Subject: Engineering, Procurement and Construction (EPC) Contract for Renovation and Modernization of Existing Navigational Lock at Farakka, West Bengal.

Reference: IN-IWAI-350002-CW-RFB-2

CPP Portal Tender no: 2023_JMVP_782597_1

CONSULTANT	NAME	SIGN	DATE
PKS FLOODKON JV	DRN		
	CHD		
	APD		
TITLE	JOB. NO.	DRG. NO.	
GENERAL LOCATION PLAN FOR MONITORING INSTRUMENTATION OF EXISTING NAVIGATION LOCK, FARAKKA		ENL014

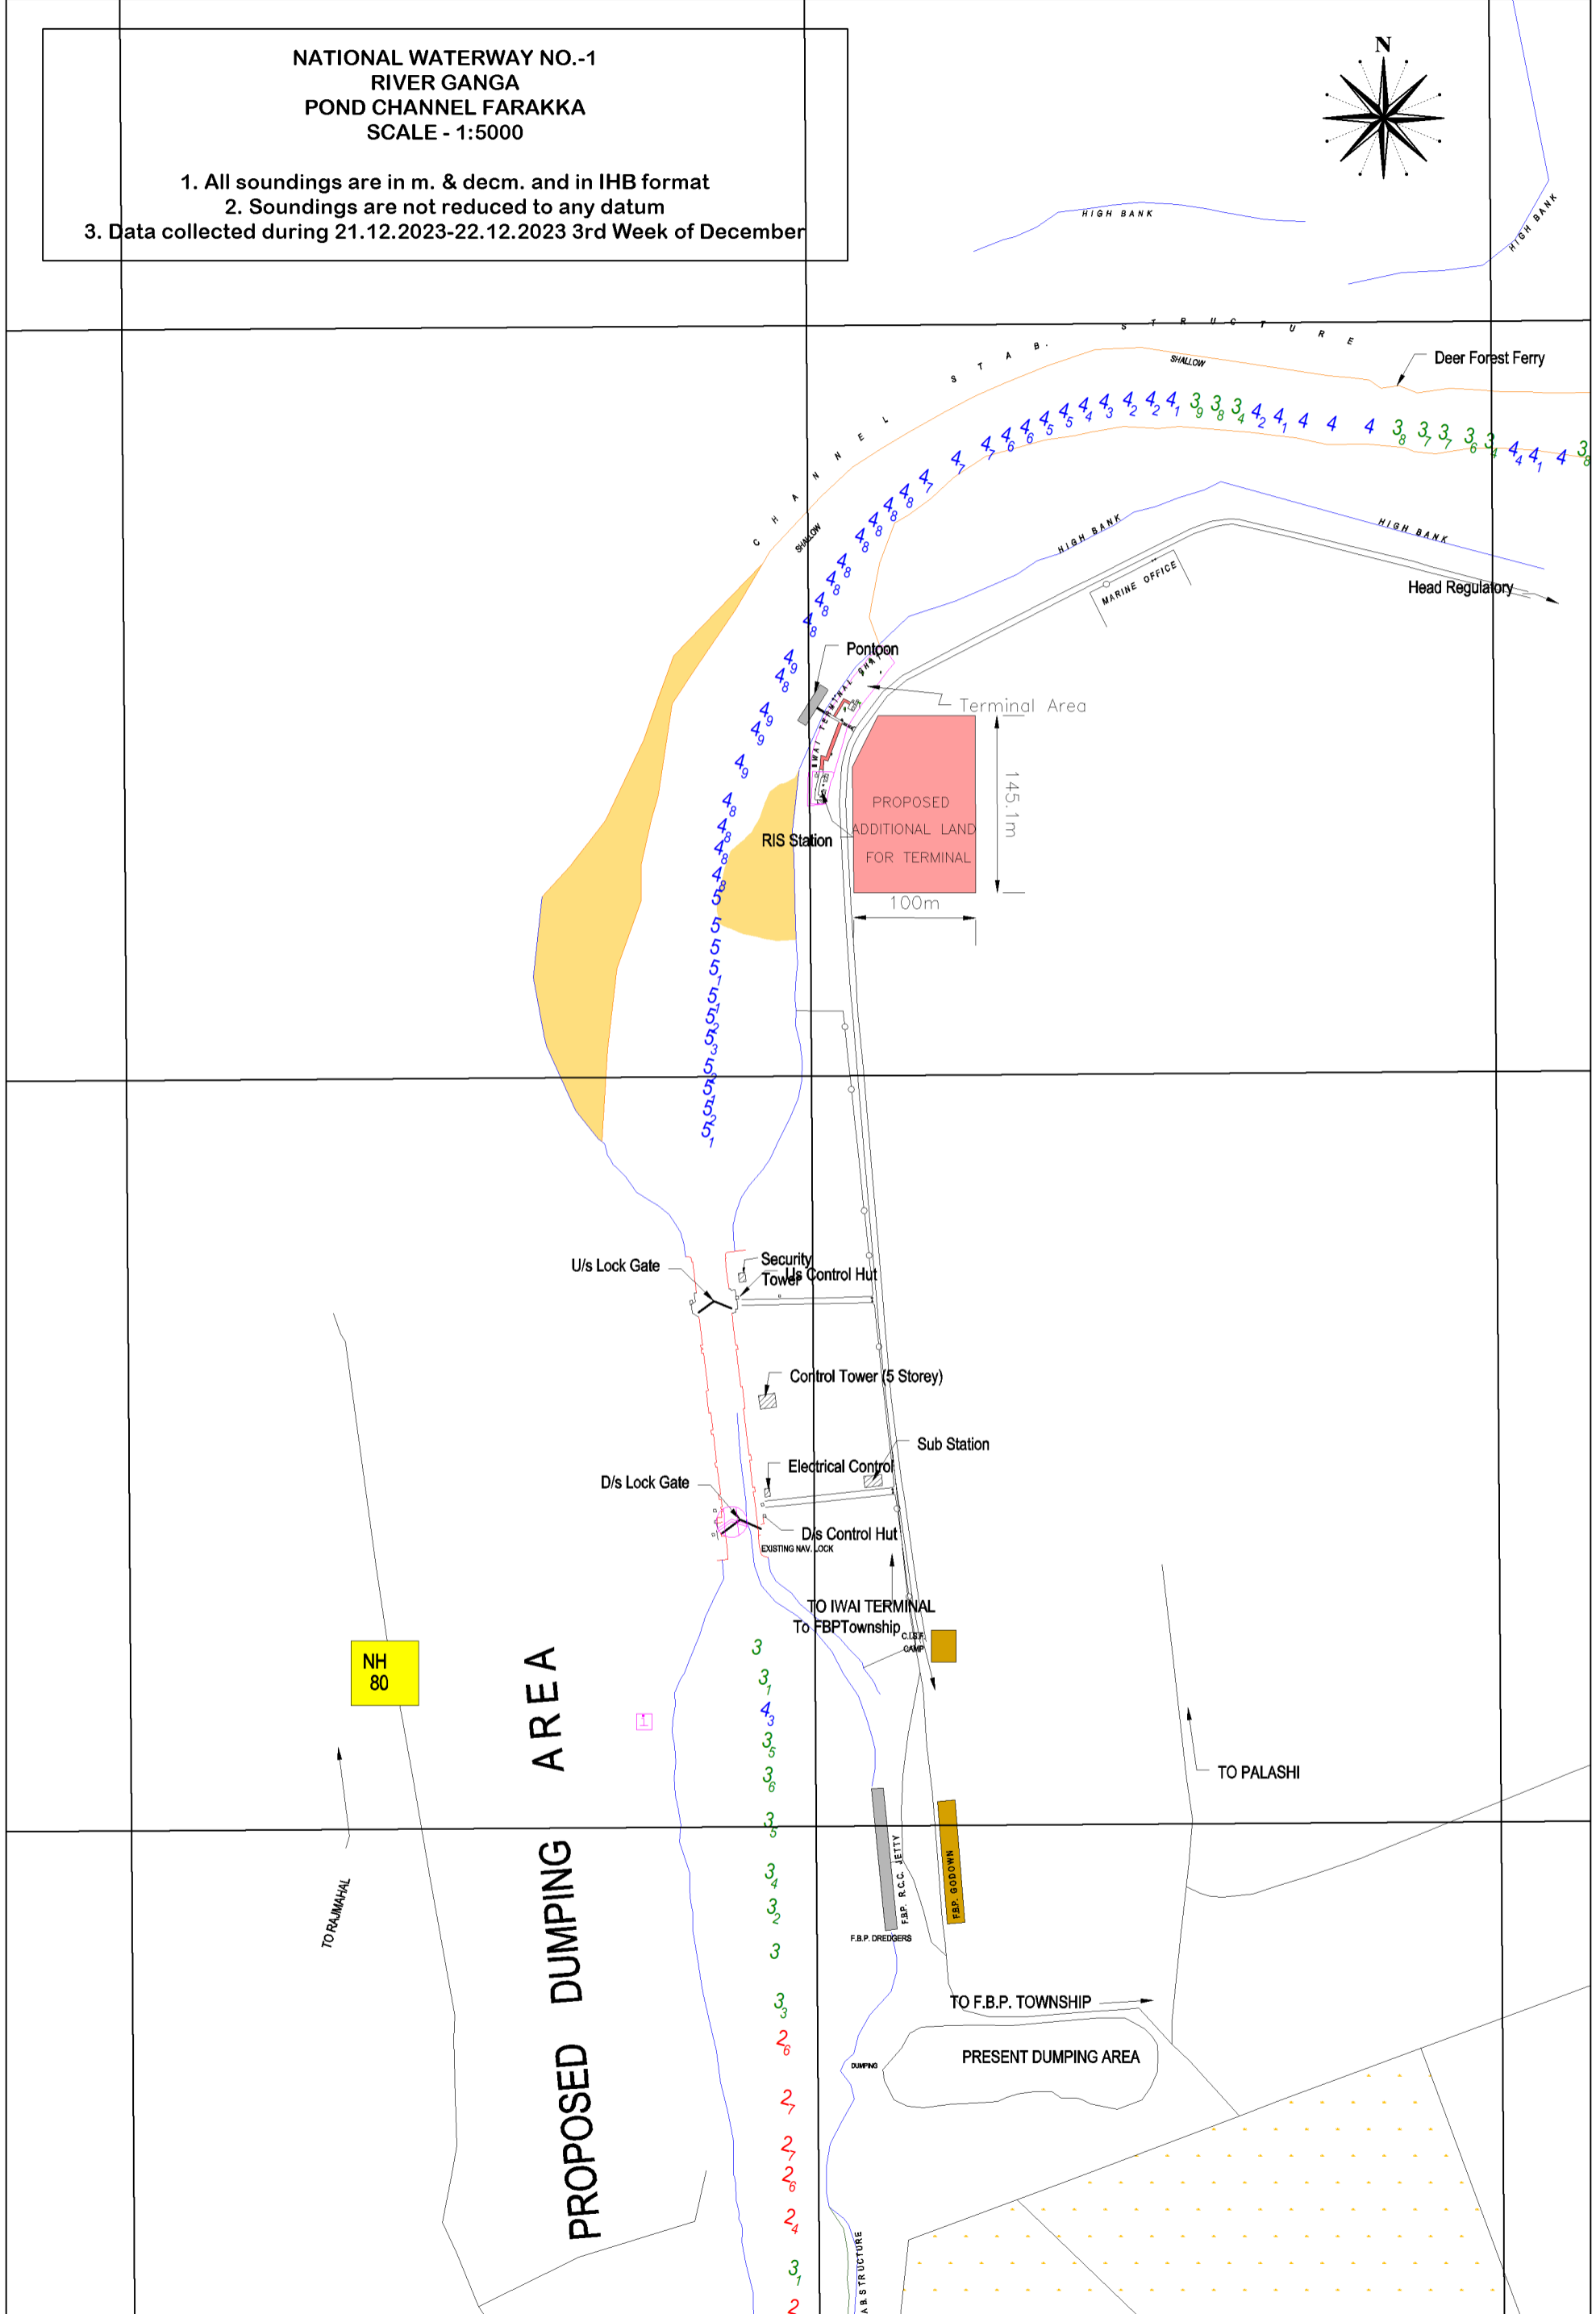
(DRG. No: ENL012)" CONTROL SYSTEM		communicated. hence we are clarifying that CCTV system will be standalone system. We are proceeding as per above said clarification. Kindly provide your confirmation.	
73	"GENERAL LOCATION PLAN FOR MONITORING INSTRUMENTATION OF EXISTING NAVIGATION LOCK, FARAKKA (DRG. No: ENL014)" "MONITORING INSTRUMENTATION"	Monitoring Instruments	As per tender drawing, Monitoring field instruments are proposed for both locks (existing and new lock structure). However, There are field instruments were already provided on single side (east bank) of new lock and single side (west bank) of existing lock during construction of new lock. Hence, Those instruments will be used for monitoring, and new instruments will be considered only for existing lock (east bank).	Tender conditions prevail.
74	Electrical "Clause: 1.2.12.2 Detailed Electrical Scope of Work" pg 33 of 571	WBSEDCL Metering Panel location	As per specification, we understood that the metering panel will be supplied by WBSEDCL. Kindly confirm the location of metering panel.	Location shall be decided as per the guidelines/ in consultation with WBSEDCL. Tender conditions prevail.
